**Re: Maverik- Albuquerque**  
**2121 Yale Blvd. SE**  
**Traffic Circulation Layout**  
Engineer's/Architect's Stamp XX-XX-XX (M15-D021D)

Based upon the information provided in your submittal received 07-26-23, the above referenced plan cannot be approved for Building Permit until the following comments are addressed:

ALBUQUERQUE, NEW MEXICO  
**MAVERIK STORE**  
2121 YALE BLVD SE  
ALBUQUERQUE, NEW MEXICO  
TRAFFIC CIRCULATION LAYOUT PLAN

THIS DRAWING IS INCOMPLETE AND NOT TO BE USED FOR CONSTRUCTION UNLESS IT IS STAMPED, SIGNED AND DATED		
Designed RWZ	Drawn RWZ	Checked DWMJR
Date:	June 2023	
Scale:	Horiz:	1" = 20'
	Vert:	N/A
Project No:	9431291	
Sheet:	TCL 1

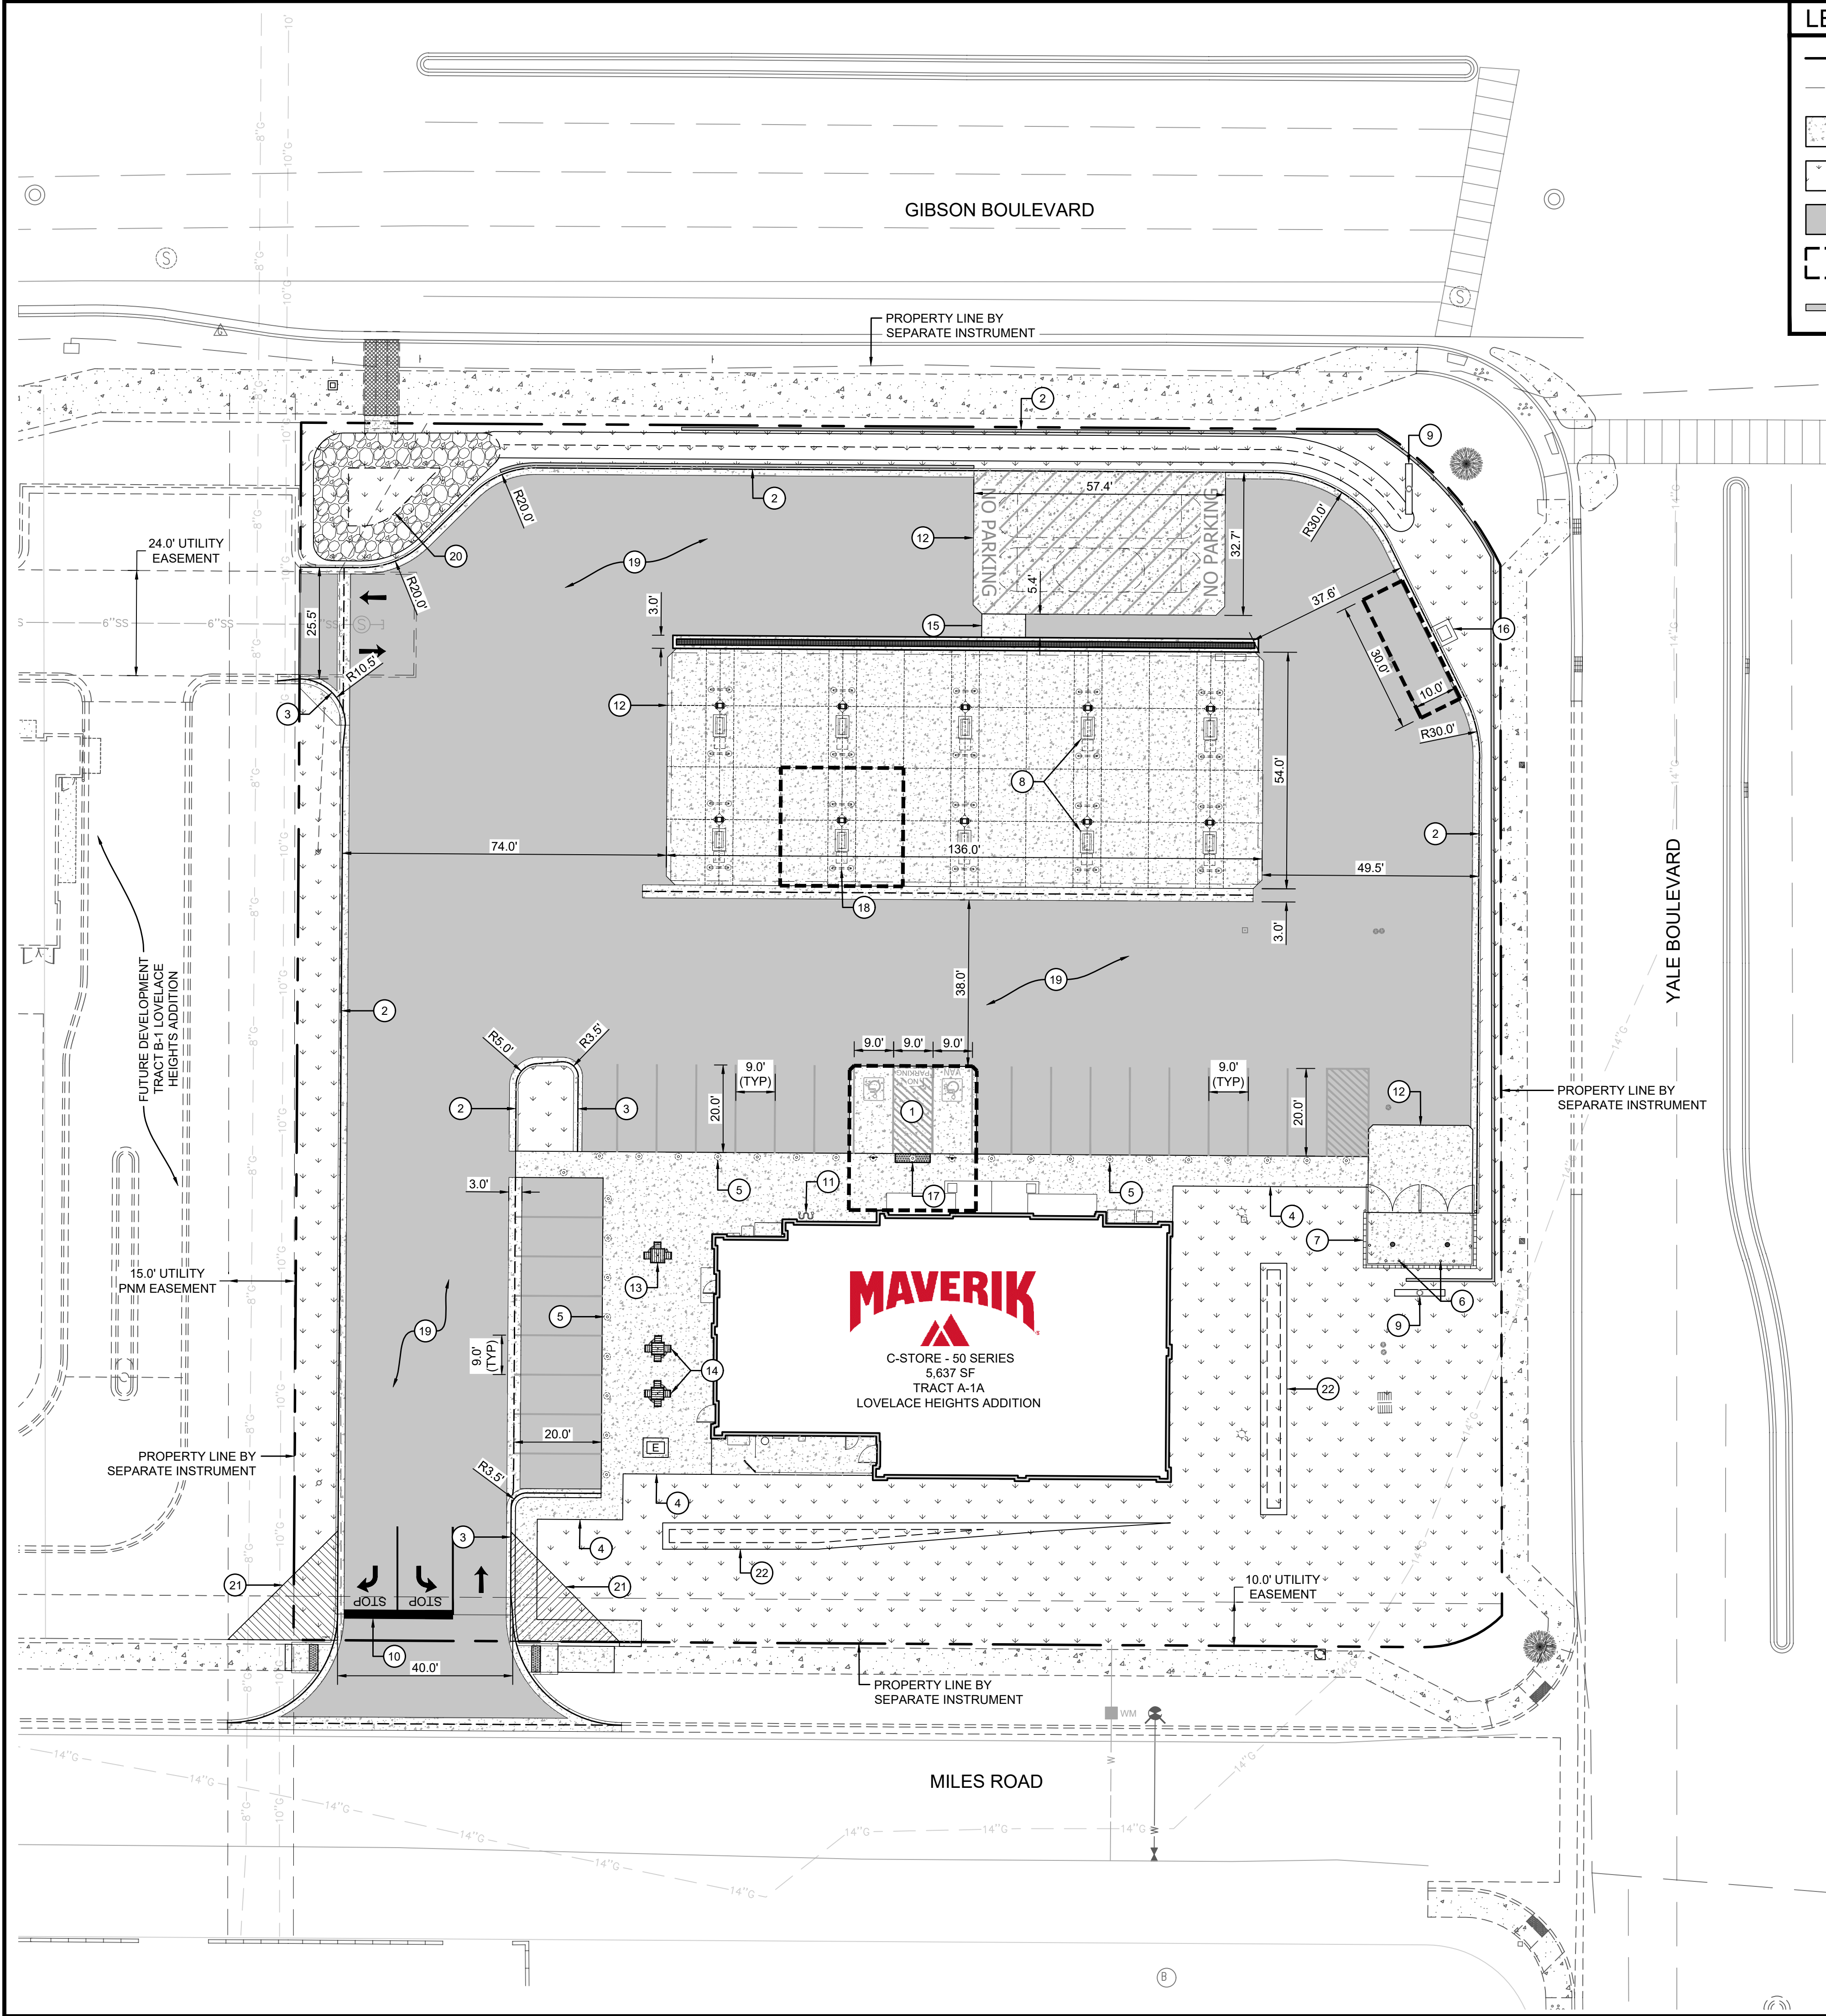
1. List the number of Motorcycle parking spaces required by the IDO.
2. The traffic circulation layout must be stamped, signed, and dated by an engineer or architect licensed in the state of New Mexico.

3. Identify all existing access easements and rights of way width dimensions.
4. Identify the right of way width, medians, curb cuts, and street widths on Gibson Blvd., Yale Blvd. and Miles Rd.

5. A minimum 5 ft. Wide sidewalk and 5 ft. wide buffer is required to be developed from property line to property line along Miles Rd. please show dimensions and details on the site plan, and reference COA std dwg 2430.

6. Please clarify: are you going to develop a sidewalk and buffer along Gibson Blvd. and Yale Blvd.? If so, please provide details and reference COA std dwg.

7. Site access off Miles: Show on the site plan the site access details and radii.
8. The ADA accessible parking sign must have the required language per 66-7-352.4C NMSA 1978 **"Violators Are Subject to a Fine and/or Towing."** Please call out detail and location of signs.

9. ADA curb ramps must be updated to current standards and have truncated domes installed.
10. Motorcycle parking spaces shall be designated by its own conspicuously posted upright sign, either free-standing or wall mounted per the zoning code.

11. The pavement marking "MC" should be shown in the opposite direction for motorcycles entering the parking space.
12. All bicycle racks shall be designed according to the following guidelines:

- 16. Per the IDO, a 6 ft. wide ADA accessible pedestrian pathway is required from the public sidewalk to the building entrances. Please clearly show this pathway and provide details.

- 17. Per DPM, a 6 ft. wide ADA accessible pedestrian pathway is required from the ADA parking stall access aisles to the building entrances. Please clearly show this pathway and provide details.

- 18. ADA accessible pedestrian pathway should not be placed behind parking space or adjacent to a vehicular way. Vehicle and pedestrian/wheel chair conflicts should be avoided as much as possible.

- 19. Refuse vehicle maneuvering shall be contained on-site. The refuse vehicle shall not back into the public right of way.; provide a copy of refuse approval.

- 25. Unused curb cuts must be replaced with sidewalk and curb & gutter. A build note must be provided referring to the appropriate City Standard drawing.
